Subject: Duke Energy Corporation
Oconee Nuclear Station - Units 1, 2, and 3
Docket Nos. 50-269, 50-270, and 50-287

Revisions to Topical Report DPC-NE-3003 In Support of
Steam Generator Replacement
Response to NRC Staff Request for Additional
Information

Duke Power Response To Request For Additional Information

DPC-NE-3003 Revision 1 “Mass and Energy Release and Containment Response Methodology”

(14.1 ft² Break - RV Outlet - Low Initial RCS Flow w/ M1 Pump Degradation Model)

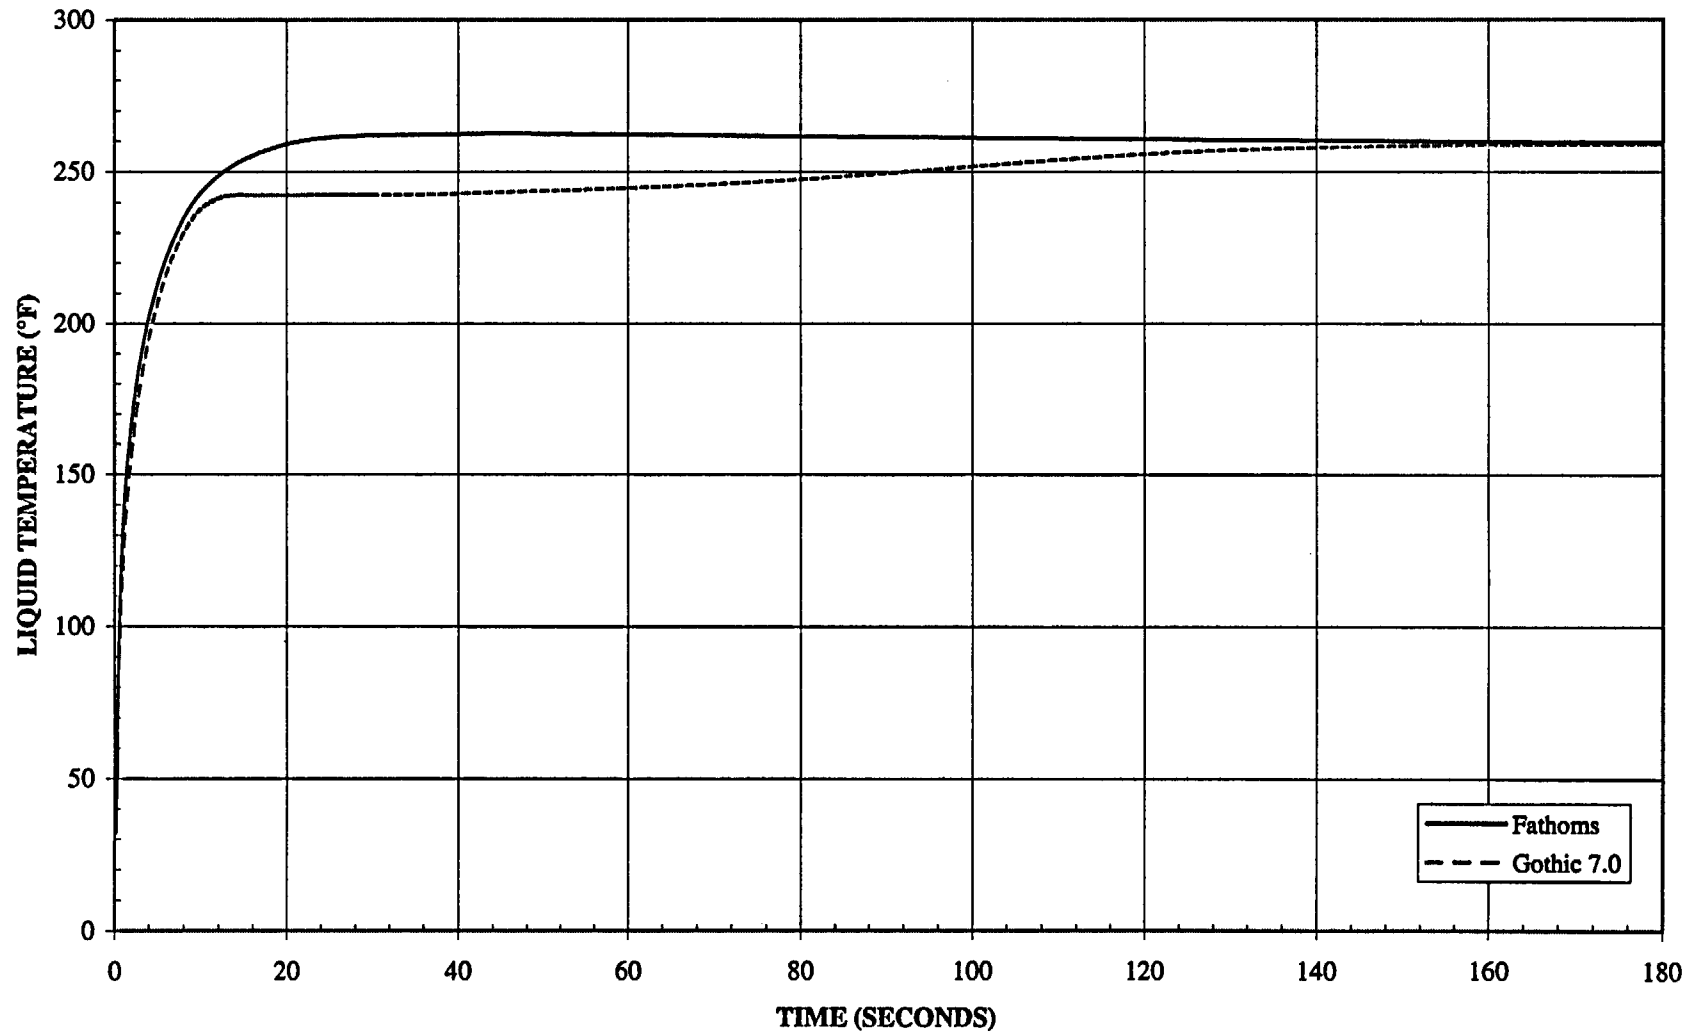
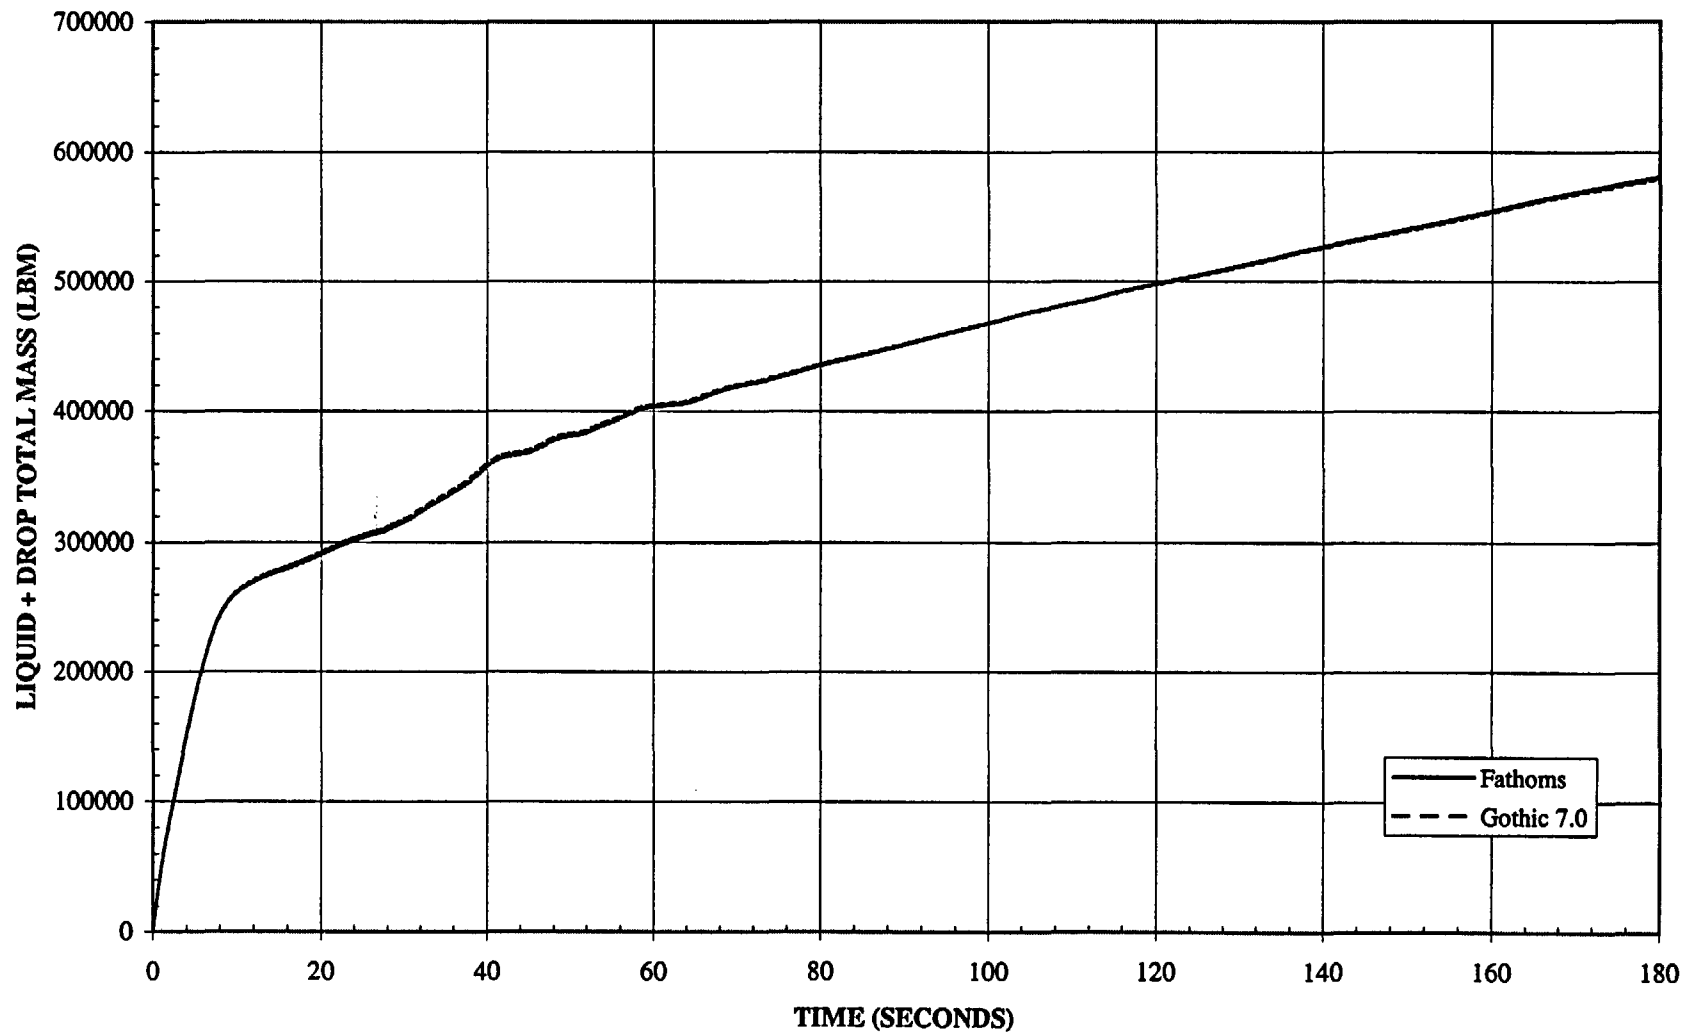
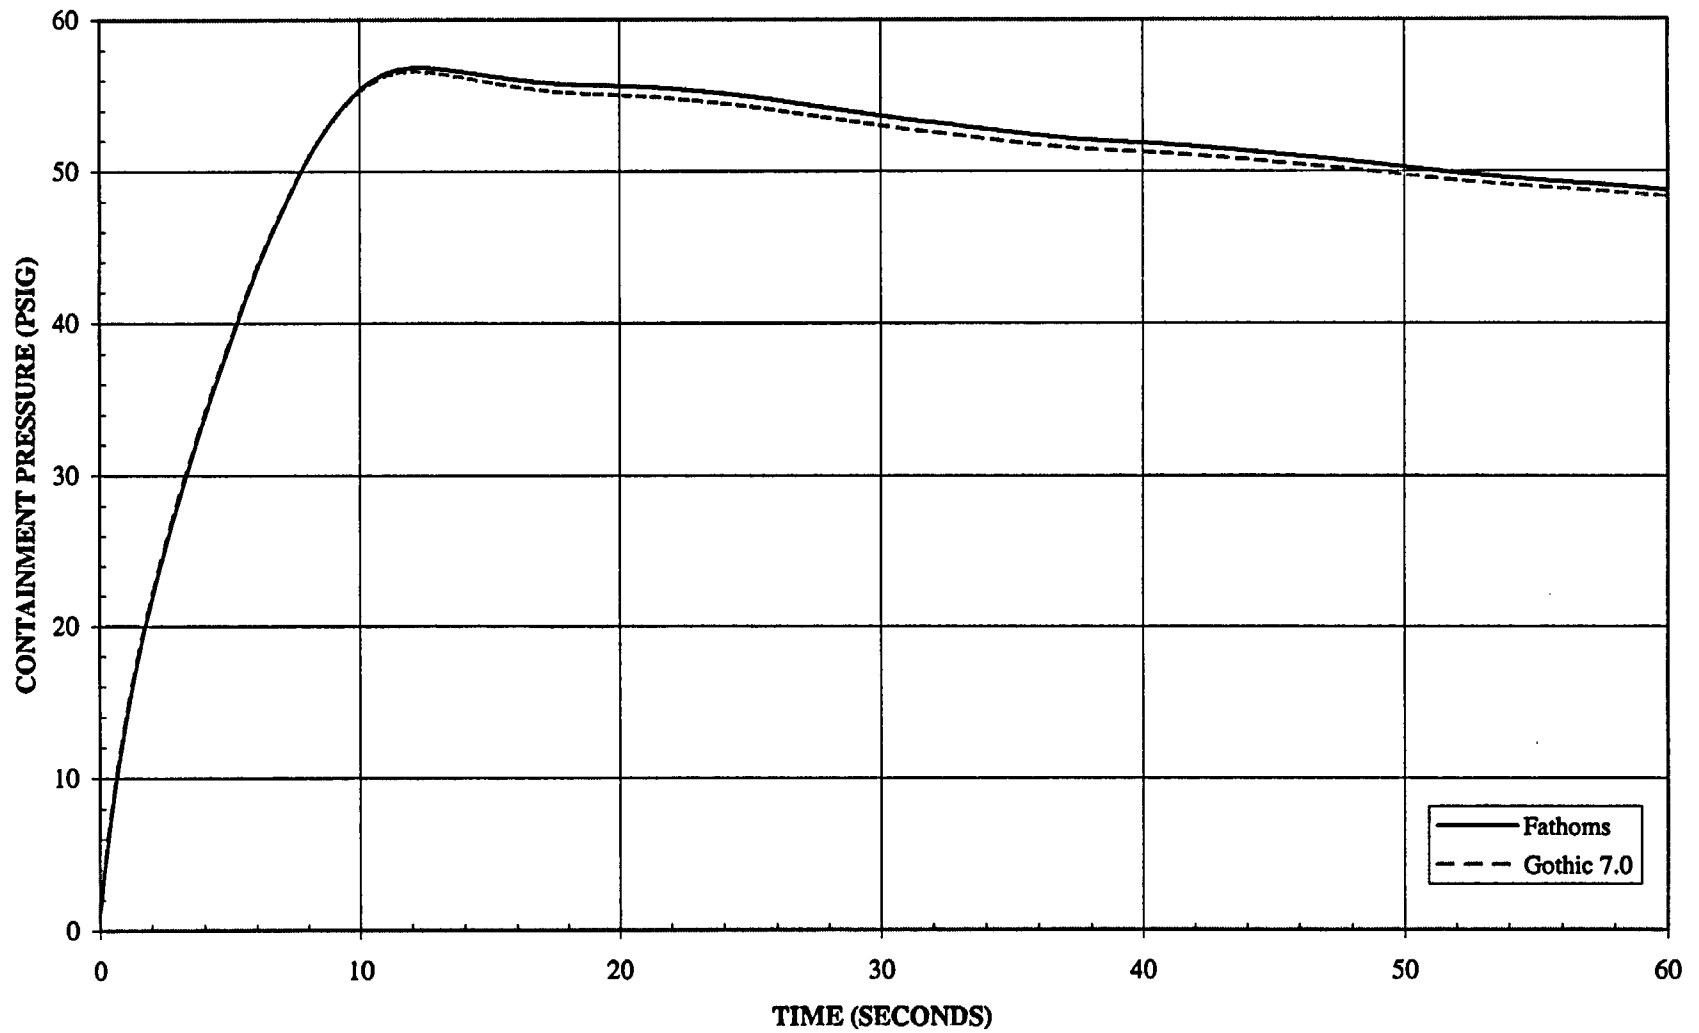
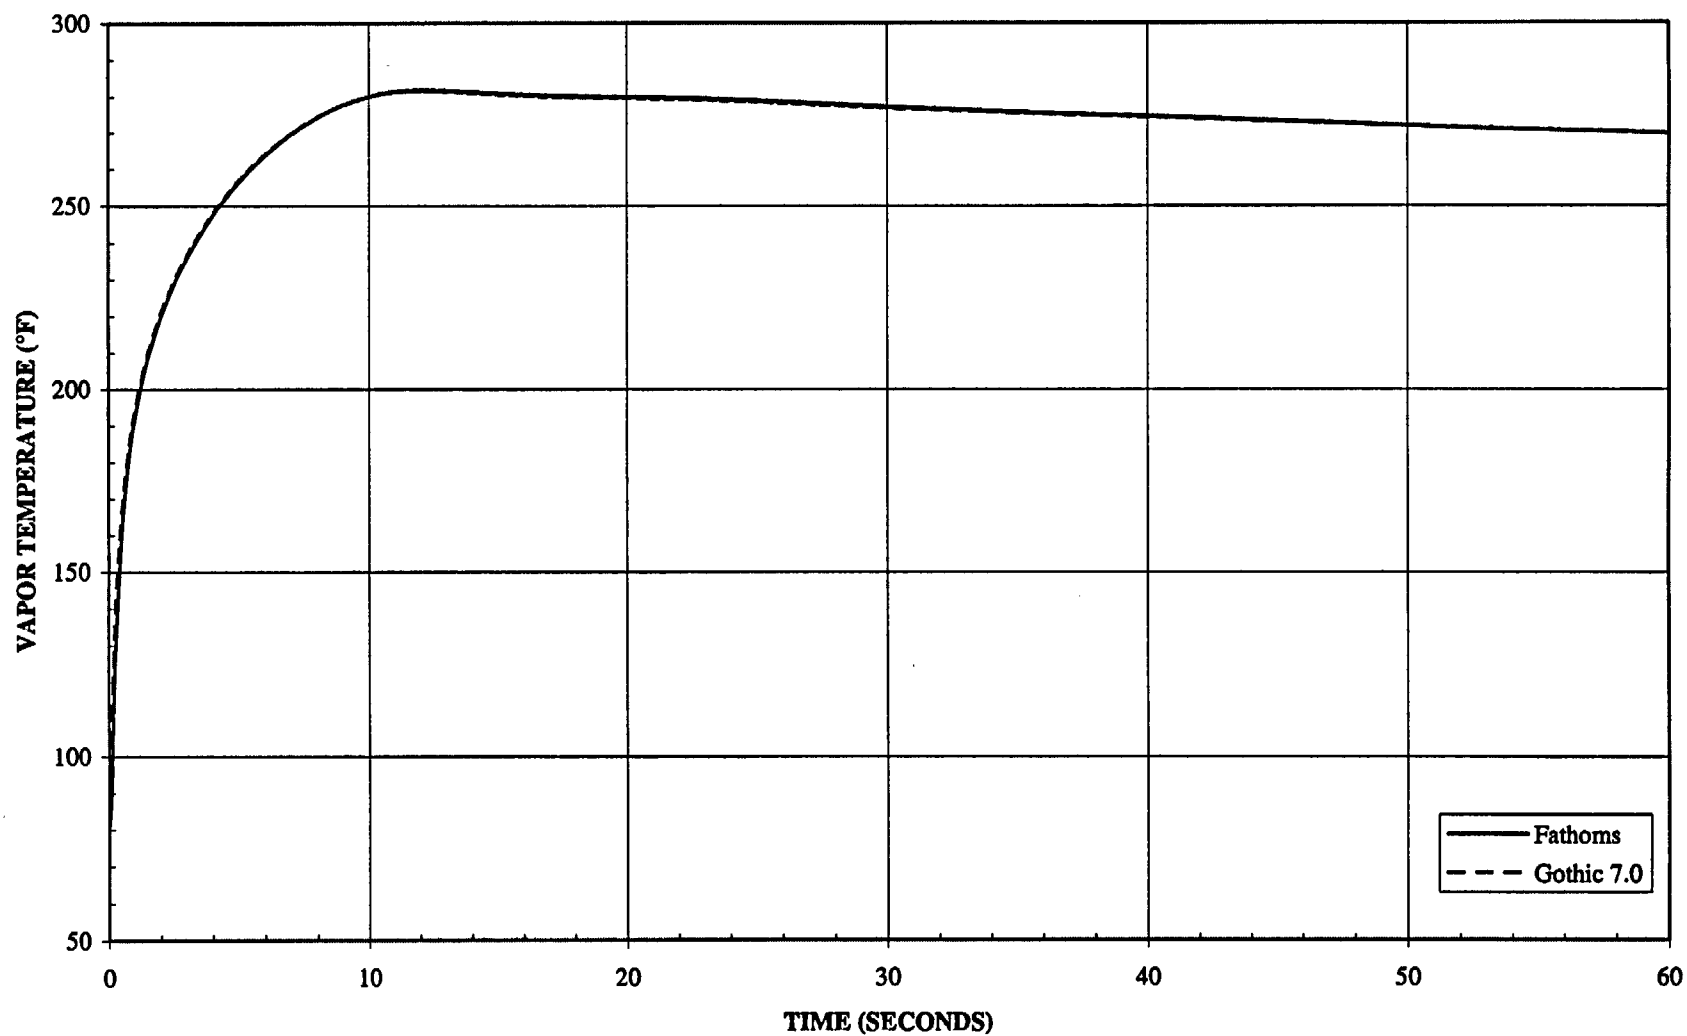
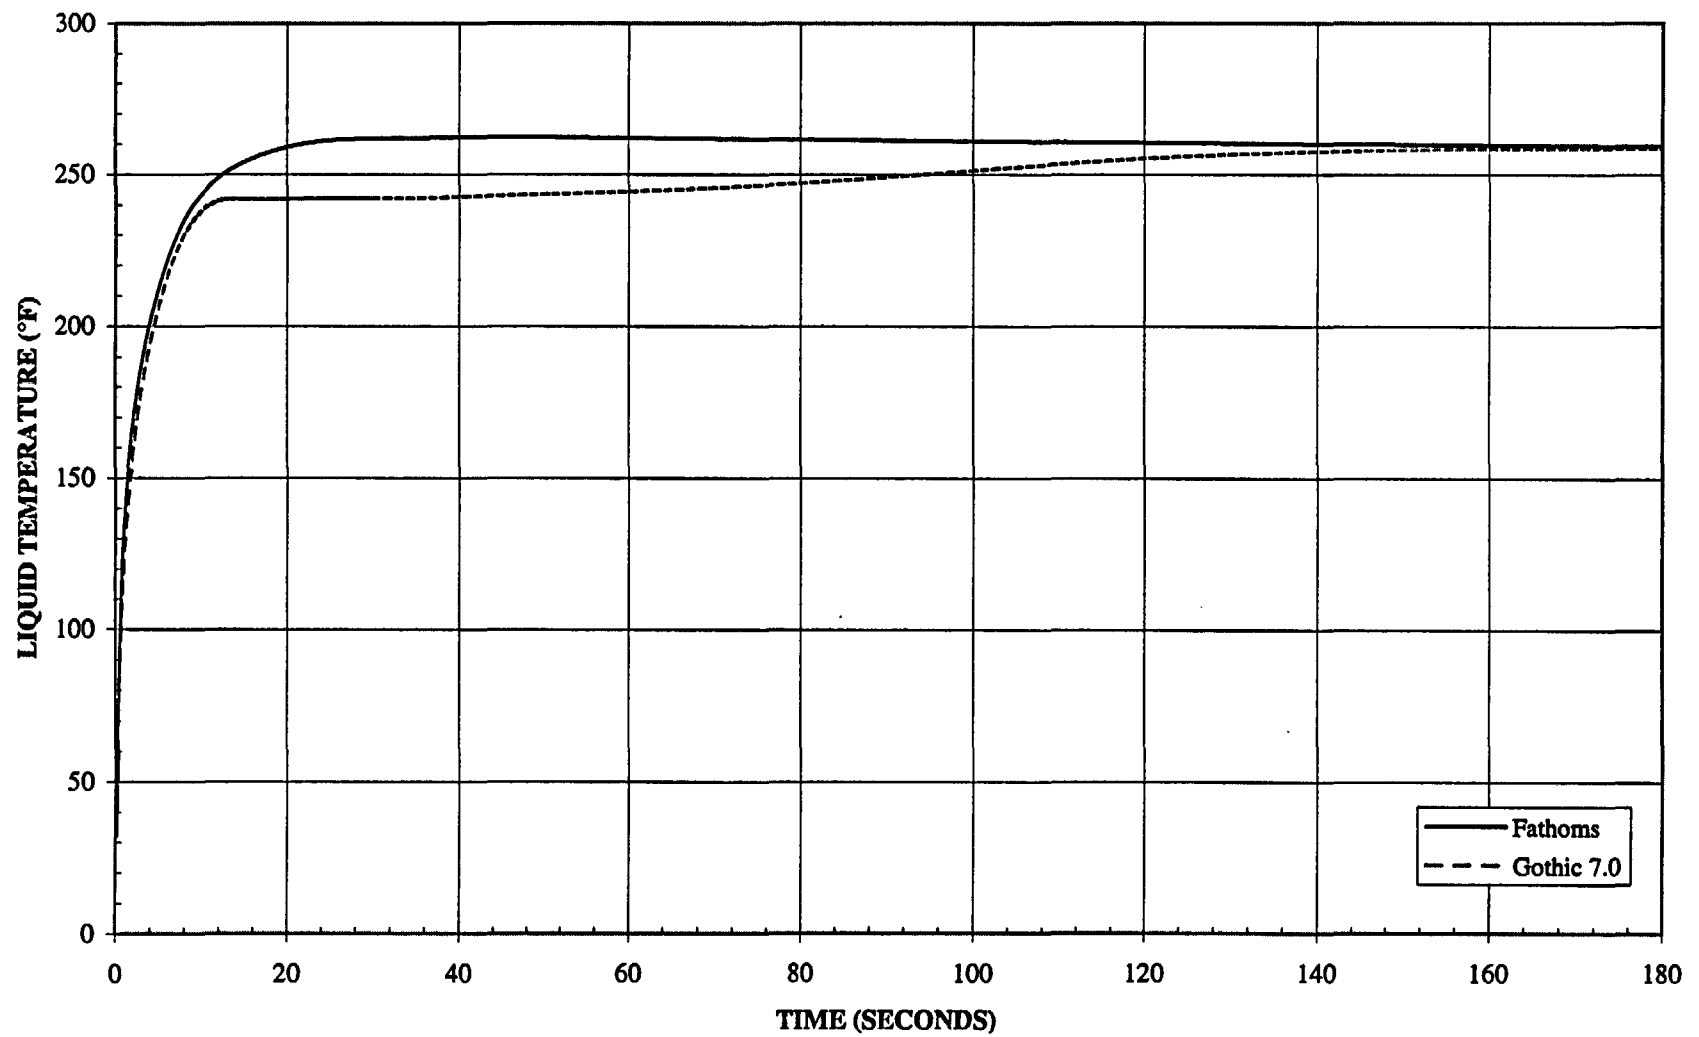
3. Please provide the results using the GOTHIC 7.0 code of peak pressure and temperature calculations for the sensitivity cases listed in Table 3.1-1 of DPC-NE-3003 in tabular and graphical form. If the results or conclusions are significantly different from those presented in DPC-NE-3003P, explain the difference.

Response: Table 3.1-1 of DPC-NE-3003 describes a spectrum of LOCA peak pressure cases including a range of break locations and sensitivity analyses for several important modeling assumptions. The staff's request is understood to focus on the difference in the predicted results from the FATHOMS and GOTHIC 7.0 code versions. Rather than show the comparison for the cases in Table 3.1-1, a different set of cases has been selected which is more focused on the current knowledge of the key sensitivity parameters. Also, the results presented are for the ROTSGs, which is the subject of Revision 1 to the topical report.

The results of the 14 code comparison analyses are shown in Table 3-1 below and in the figures that follow. In general, the pressure and vapor temperature response predictions were very similar in both magnitude and trend. GOTHIC 7.0 predictions for peak pressures and vapor temperature were slightly lower (~0.5 psig and 0.5°F). These differences are consistent with the code model differences described in the response to Question #1. Both codes predict a saturated containment atmosphere due to the large amount of drops injected. The slightly lower pressure, vapor temperature, and liquid temperature from GOTHIC 7.0 may be attributed to additional drop hold up in the atmosphere. This effectively increases the heat capacity of the atmosphere and reduces the temperature rise for a given energy addition. A comparison of the total liquid and drop masses, and liquid temperatures, show the predictions of the two codes to be essentially the same. This is consistent with the changes in the drop deposition and entrainment models discussed in Question #1. These results show that the two code versions give essentially similar results for the same break location and initial and boundary conditions.
